UNITED STATES
DEPARTMENT OF THE INTERIOR
BUREAU OF LAND MANAGEMENTNM OIL CONSERVATION
ARTESIA DISTRICTFORM APPROVED
OMB NO. 1004-0135
Expires: July 31, 2010**SUNDRY NOTICES AND REPORTS ON WELLS**
Do not use this form for proposals to drill or to re-enter an abandoned well. Use form 3160-3 (APD) for such proposals.

7. If Unit or CA/Agreement, Name and/or No.
891014168X8. Well Name and No.
NASH UNIT 44H9. API Well No.
30-015-42195-00-X110. Field and Pool, or Exploratory
NASH DRAW11. County or Parish, and State
EDDY COUNTY, NM1. Type of Well
☒ Oil Well ☐ Gas Well ☐ Other2. Name of Operator
XTO ENERGY INCORPORATEDContact: STEPHANIE RABADUE
E-Mail: stephanie_rabadue@xtoenergy.com3a. Address
200 LORAIN SUITE 800
MIDLAND, TX 797013b. Phone No. (include area code)
Ph: 432-620-67144. Location of Well (Footage, Sec., T., R., M., or Survey Description)
Sec 18 T23S R30E Lot 1 0500FNL 330FWL

Sundry dated 6/25/2014

GRADE D PRESSURE TEST CERTIFICATE

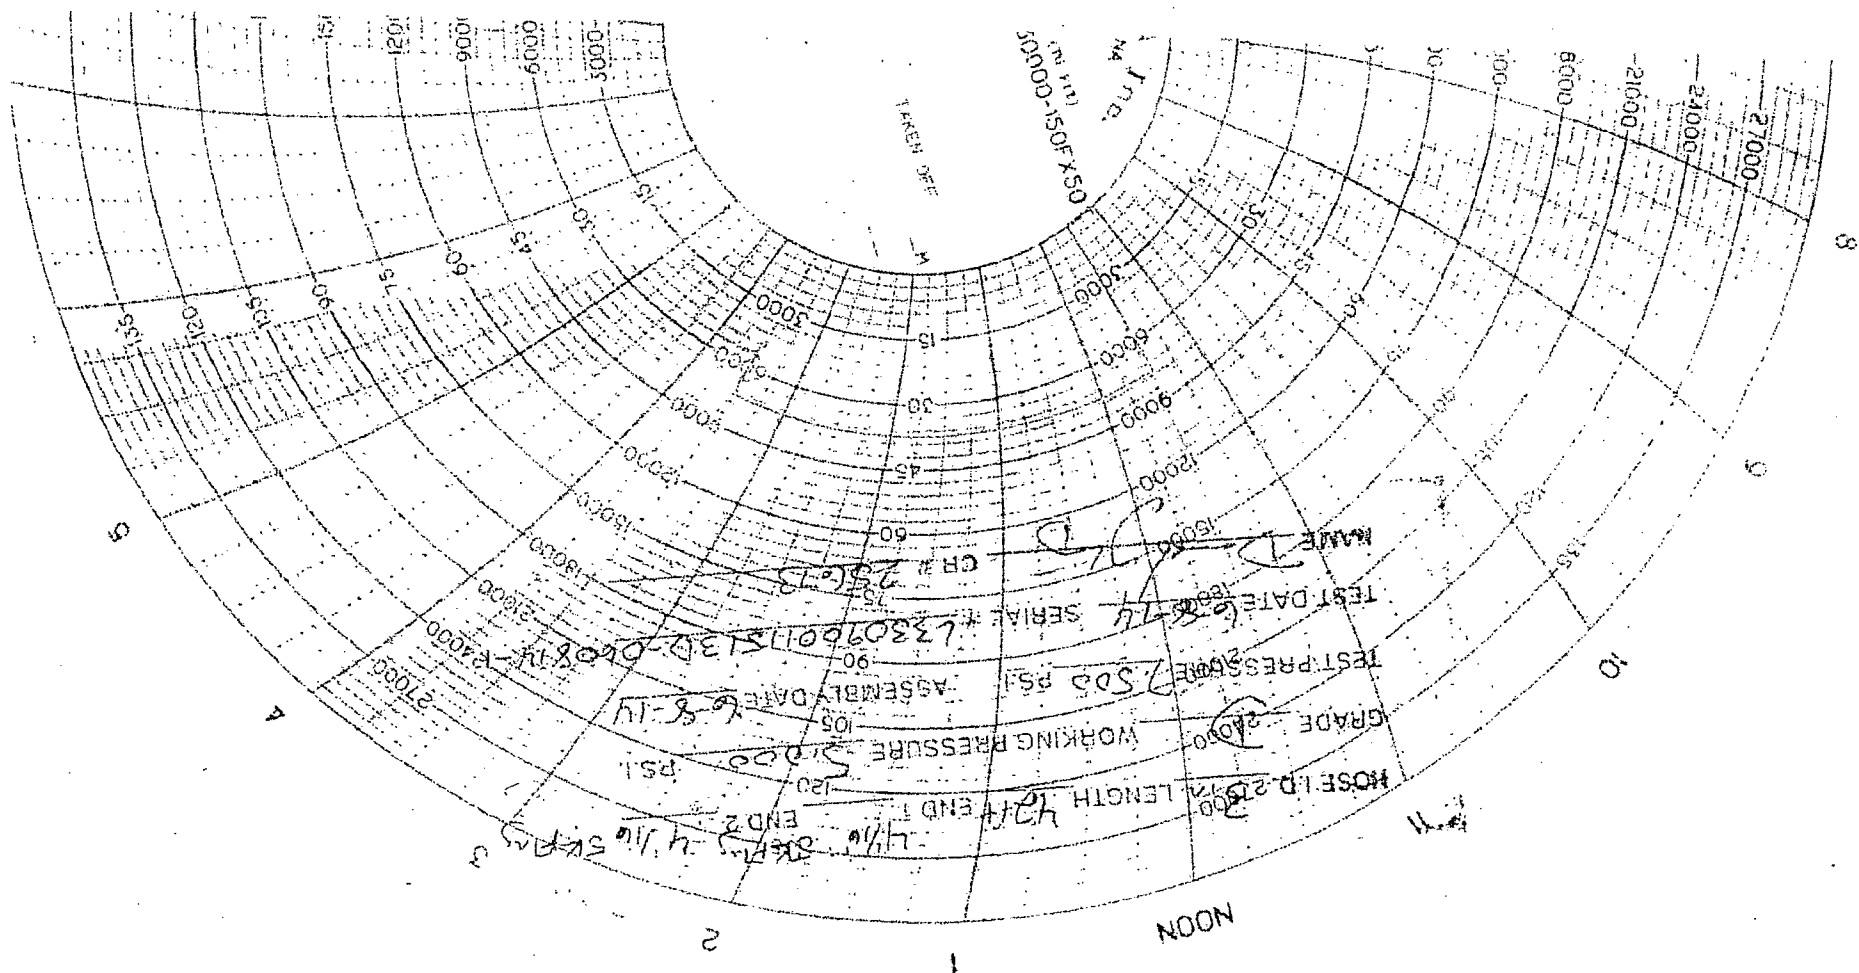
3)XTO Energy requests a variance from the requirements to use straight hard line as the choke line and instead use a flex hose. Pioneer 33 is outfitted with a Gates E&S flex hose rated to 5,000 psi working pressure (serial# D-060814-1). See attached for test certificate and copy of the pressure test chart.

2. Variance approved to use flex line from BOP to choke manifold. Check condition of flexible line from BOP to choke manifold, replace if exterior is damaged or if line fails test. Line to be as straight as possible with no hard bends and is to be anchored according to Manufacturer's requirements. The flexible hose can be exchanged with a hose of equal size and equal or greater pressure rating. **Anchor requirements, specification sheet and hydrostatic pressure test certification matching the hose in service, to be onsite for review.** If the BLM inspector questions the straightness of the hose, a BLM engineer will be contacted and will review in the field or via picture supplied by inspector to determine if changes are required (operator shall expect delays if this occurs).
